Western Sub Regional RTEP: AEP Supplemental Projects

October 20, 2023

Changes to the Existing Projects

AEP Transmission Zone: Supplemental S1598 Scope change

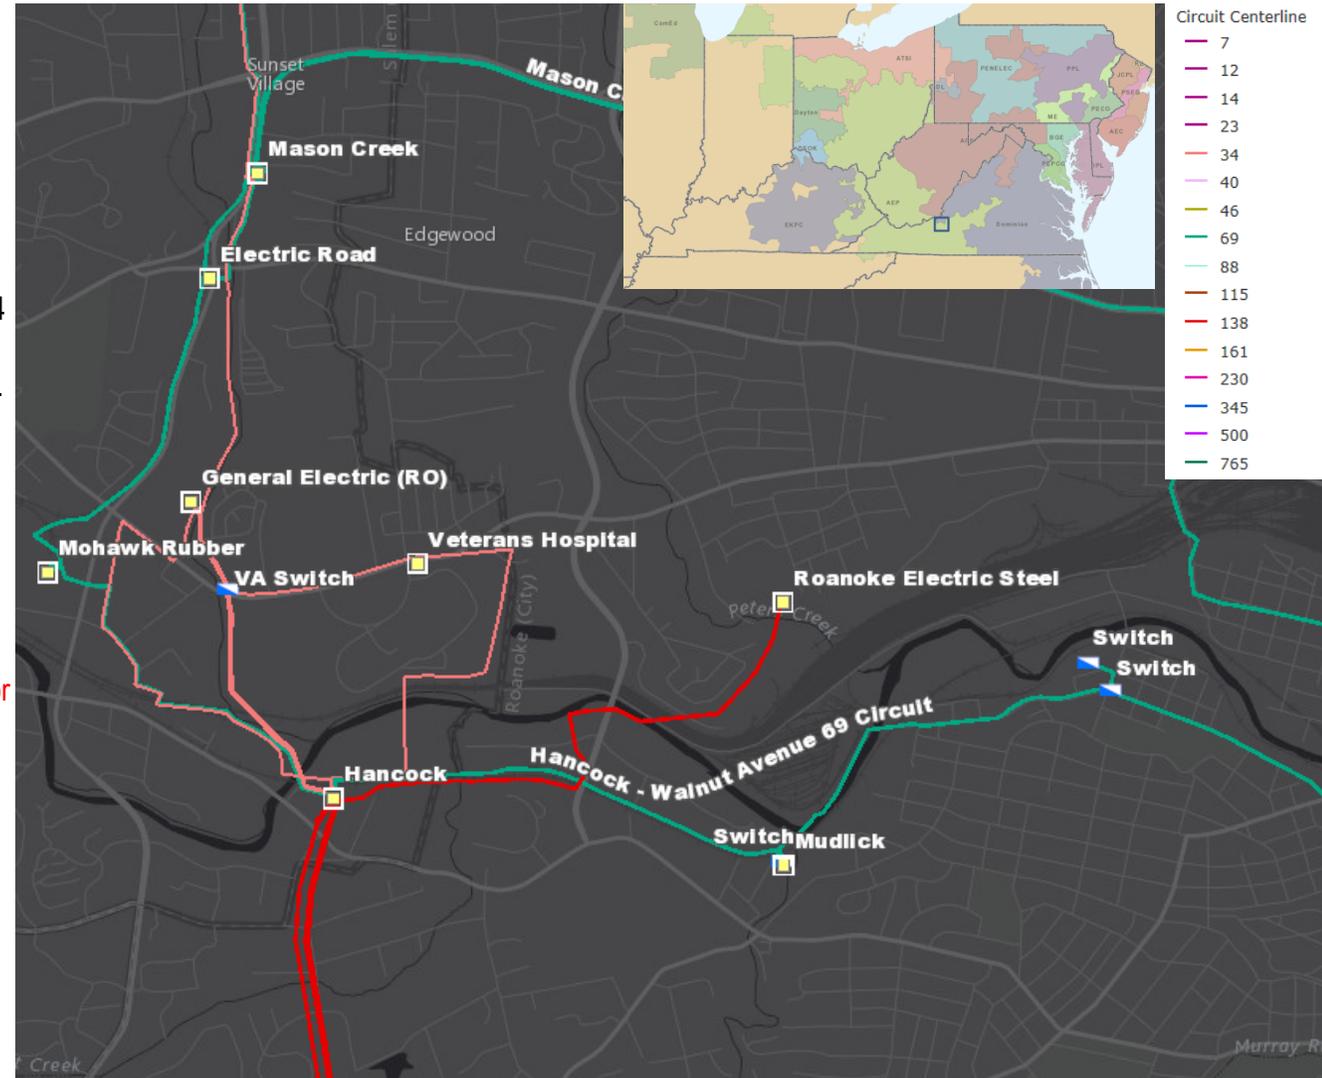
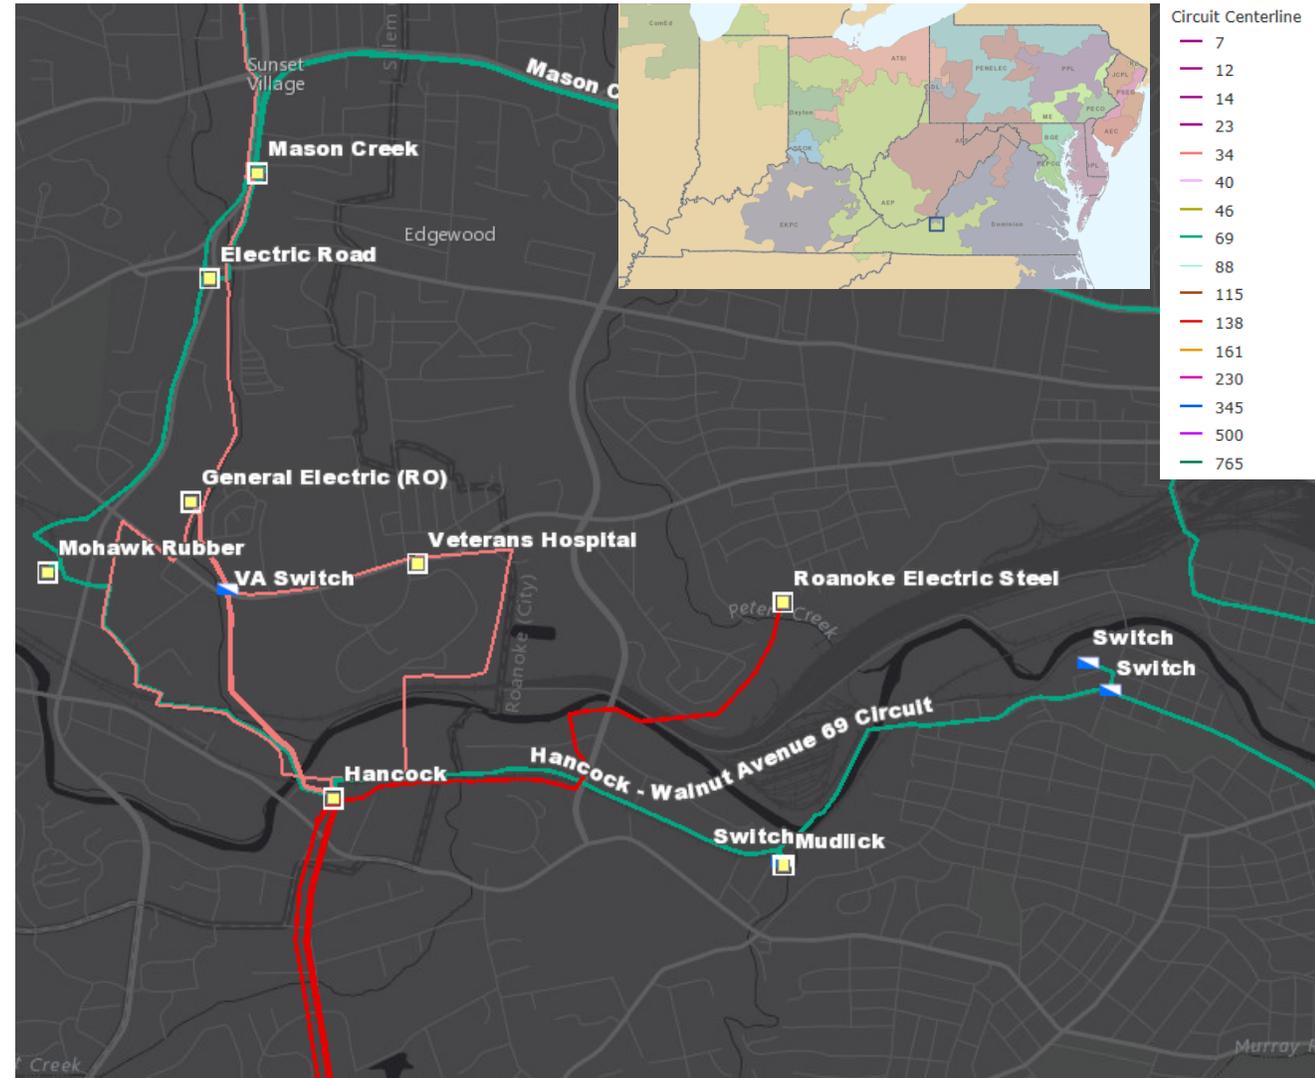
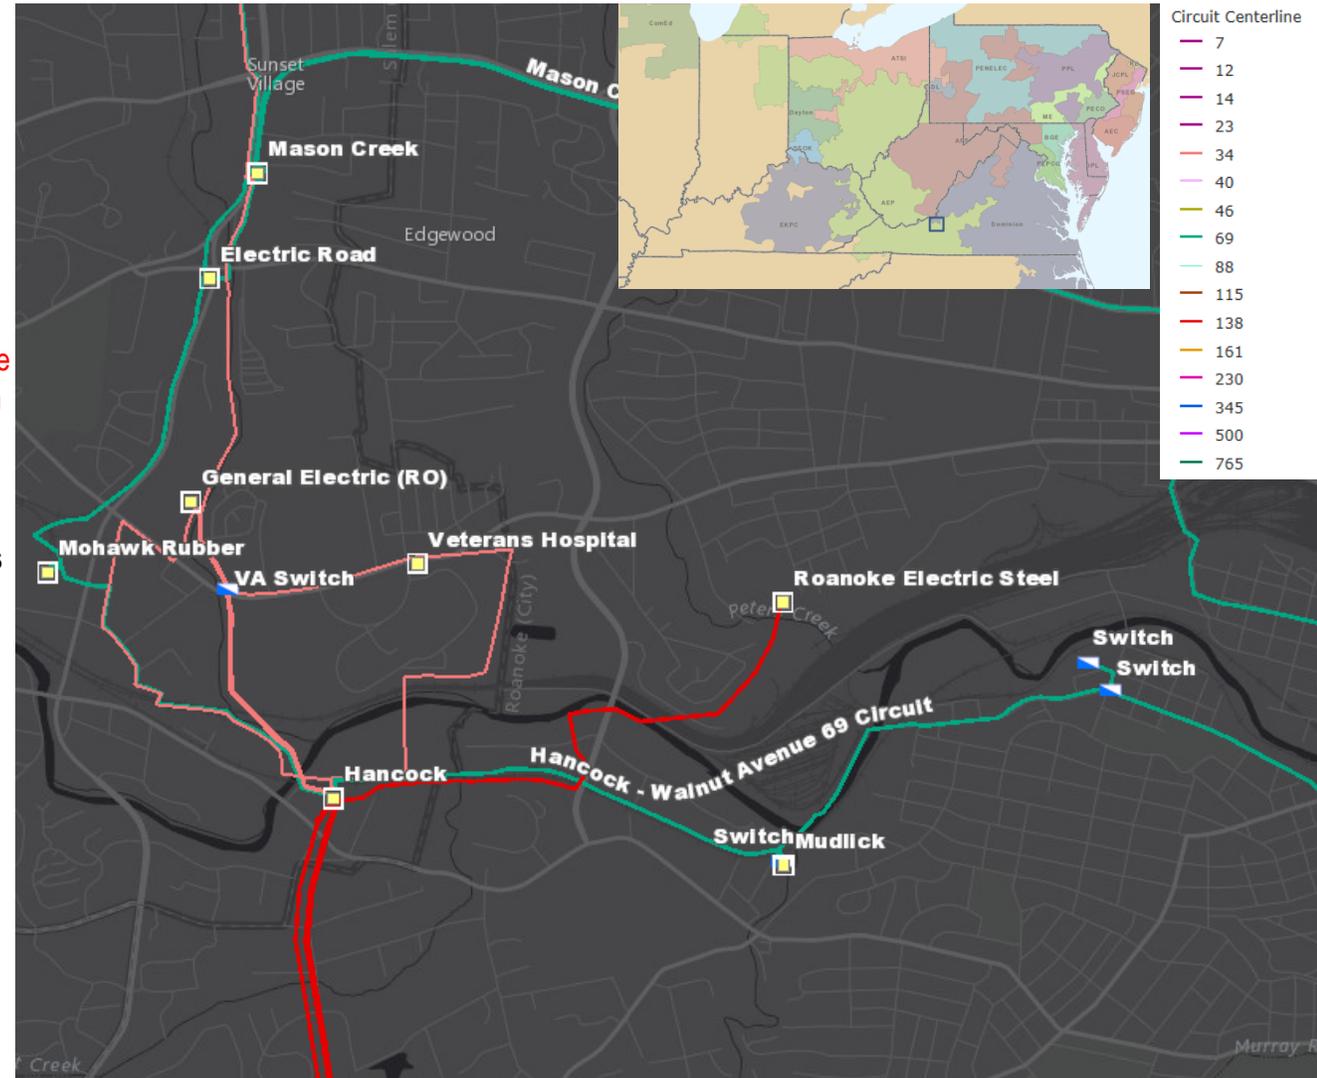
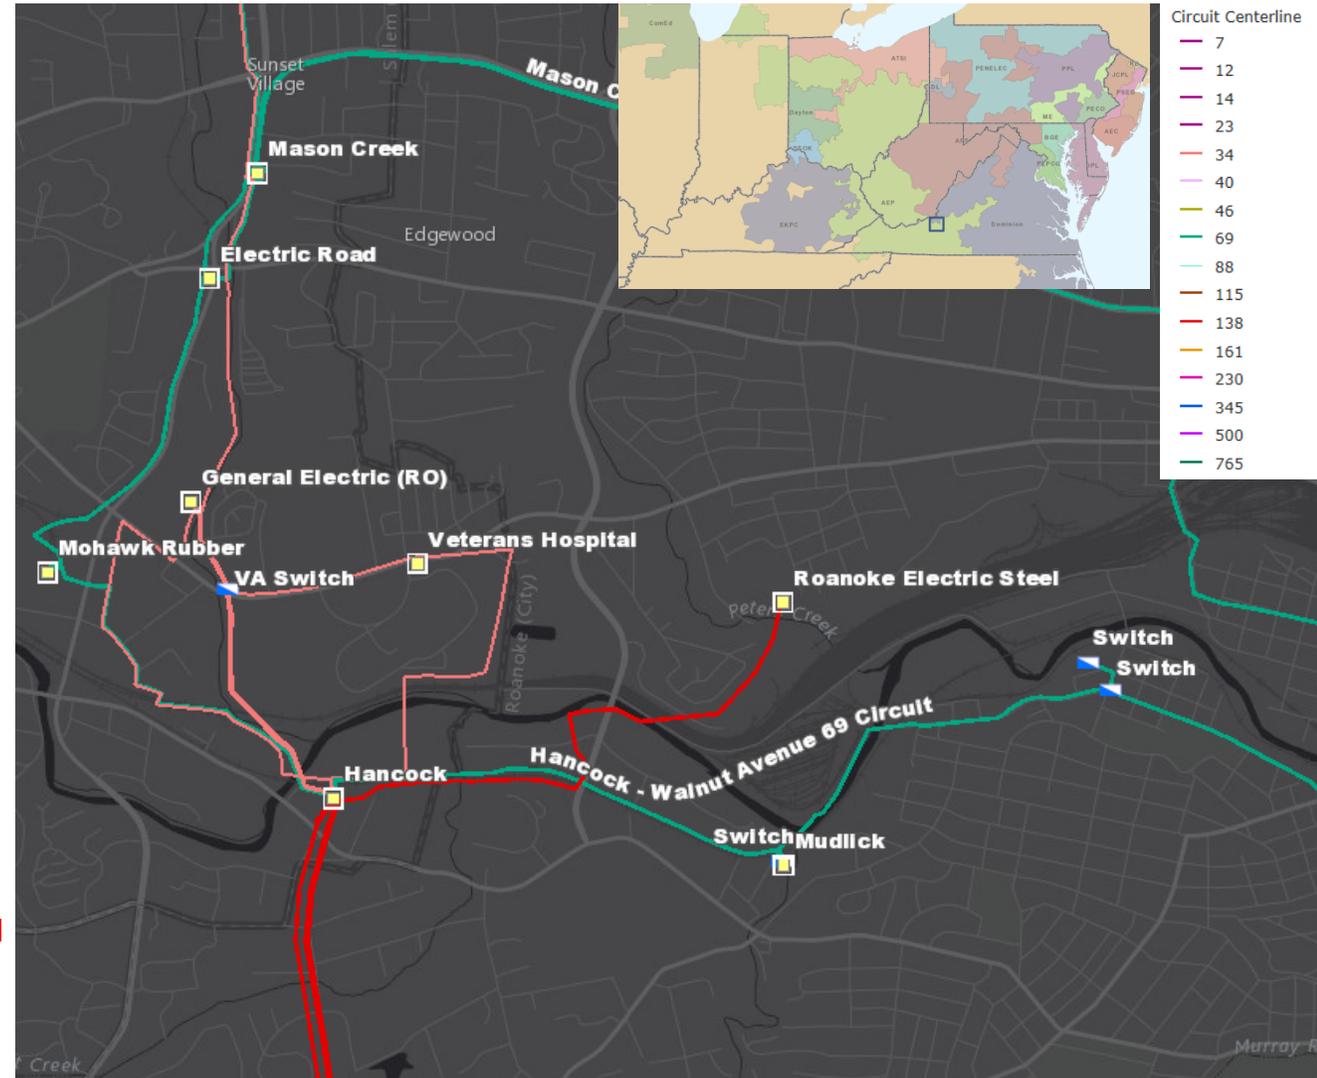
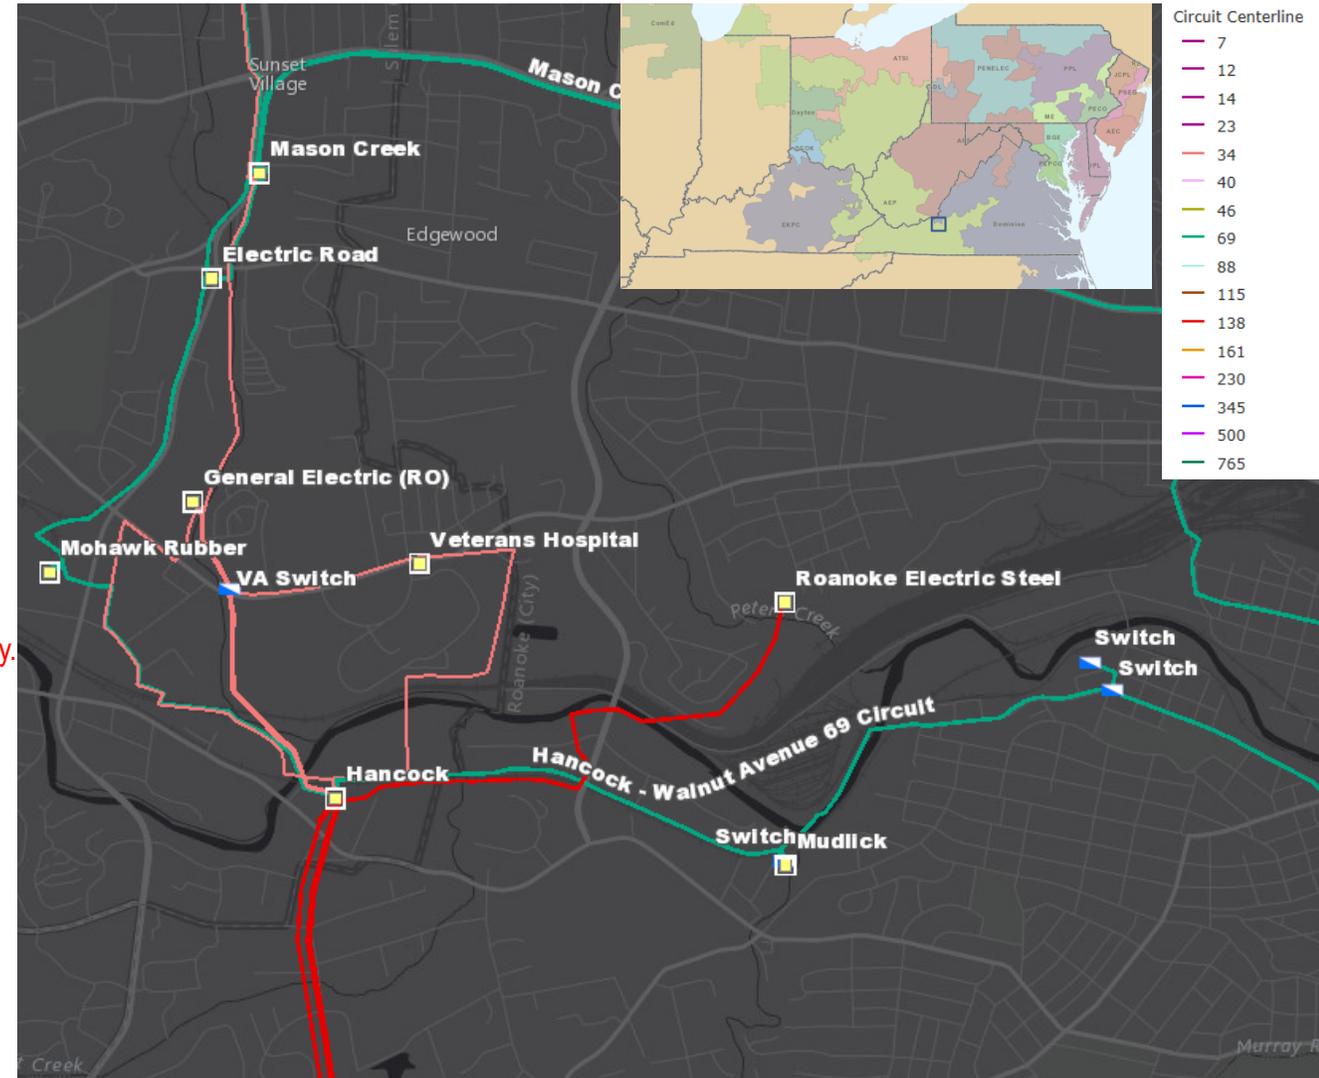
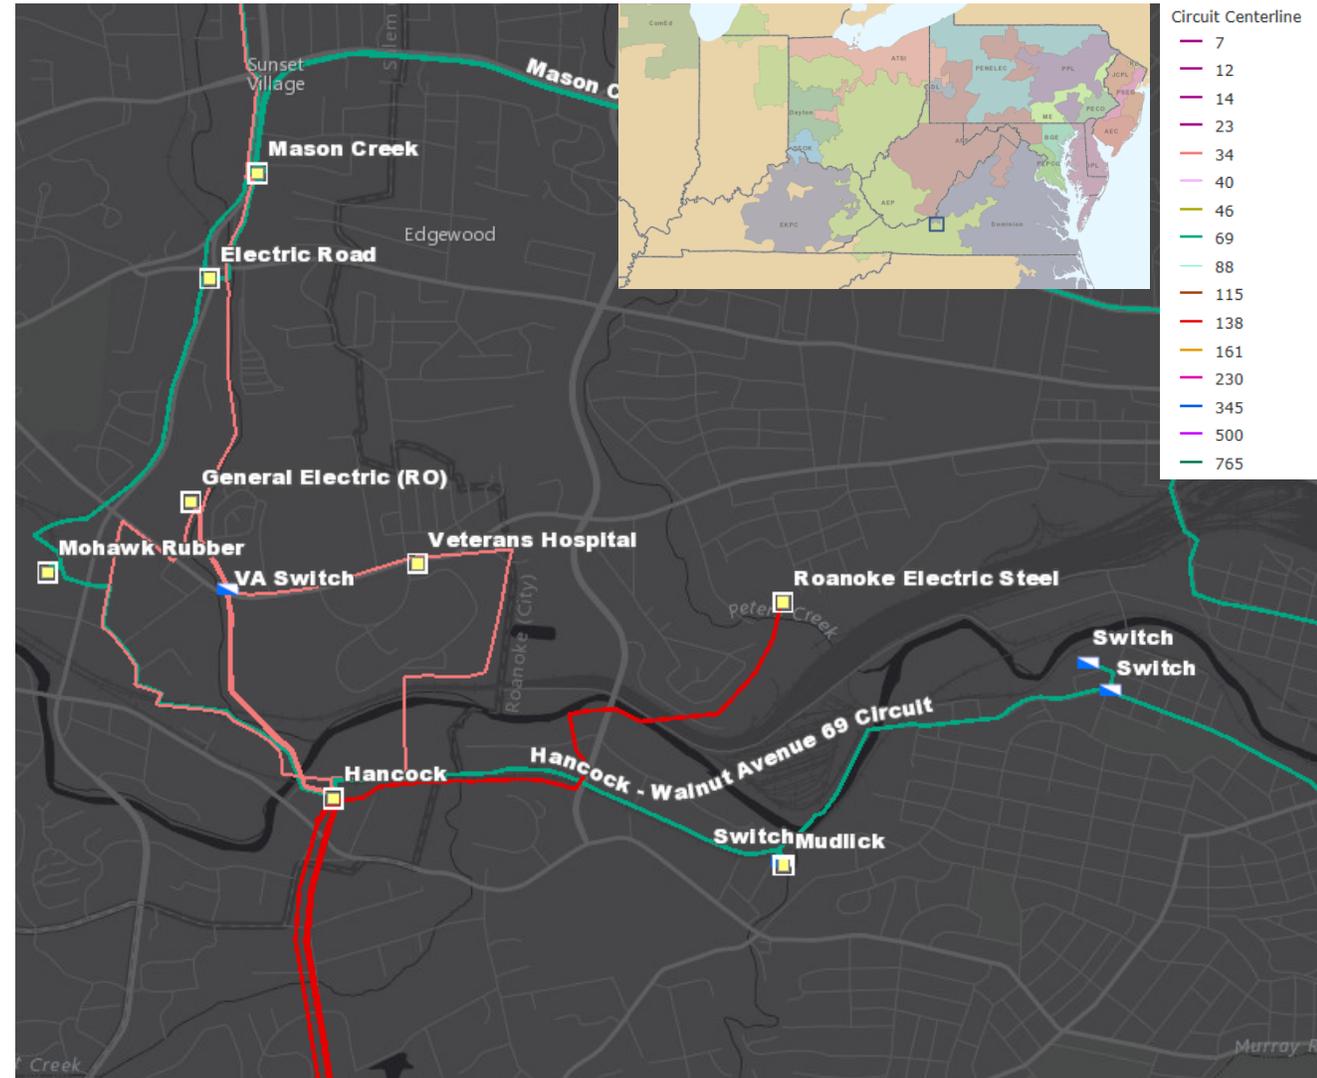
Changes are marked in red

Hancock station 138 kV circuit breakers 'A', 'B' & 'C', ~~69 kV circuit breakers 'CA', 'M' and 'N'~~, 34 kV circuit breakers 'J', ~~'I', 'P', 'R' & 'S'~~ are oil type breakers without oil containment. In general, oil breakers have become increasingly difficult to maintain due to the oil handling requirements. Oil spills are frequent with failures and routine maintenance which is also an environmental hazard. Other drivers include damage to bushings. CBs 'A', 'B', 'C', ~~'CA', 'N', 'J', 'I' & 'P'~~ are also legacy oil-filled FK type breakers which have little to no replacement parts. ~~69kV circuit breaker 'Q' is a EPB Gas Circuit Breaker with gas leaks, bushing failures and CT gasket problems.~~

Reason for Revision:

The initially proposed breaker and a half configuration was determined not to be feasible physically. Also, after additional engineering investigation, the 138 kV bus work was in relatively good condition and the 34.5 kV equipment was in need of repair. Several of the 69 kV and 34.5 kV circuit breakers had already been replaced.

Potential Solution

- Replace 138 kV CBs A, B, C and associated disconnect switches, foundations, and CCVTs
- Install 2 additional 138 kV bus tie breakers and utilize the position between the breakers to feed Roanoke Electric Steel

- Replace 138/69/34.5 kV T1, install a high-side circuit switcher and change connection to bus #1, Install ground bank on 69 kV side
- Replace 138/34 kV T2, install a high-side circuit switcher, new foundations, add oil containment, Install ground bank on 69 kV side

- Replace 138 kV, 50.4 MVar Capacitor Bank and Circuit Switcher BB, associated switches and foundation
- Replace all Transmission 34.5 kV bus work, circuit breakers, associated disconnect switches and foundations. Replacement 34.5 kV breakers will be 3000 A, 40 kA. Replace 34.5 kV capacitor bank AA with 9.6 MVar bank, associated circuit switcher and foundation.

- Expand control house and replace all electromechanical relays (116), 7 static relays and 9 microprocessor relays
- Install 138/34.5 kV 30 MVA non-LTC Transformer with high side circuit switcher replacing the non-standard 34.5/34.5 kV configuration and removing the N.O. by-pass around 34.5 kV CB K

Estimated Cost: \$30.5 M

Projected In-service: ~~4/21/2024~~ 10/14/2024
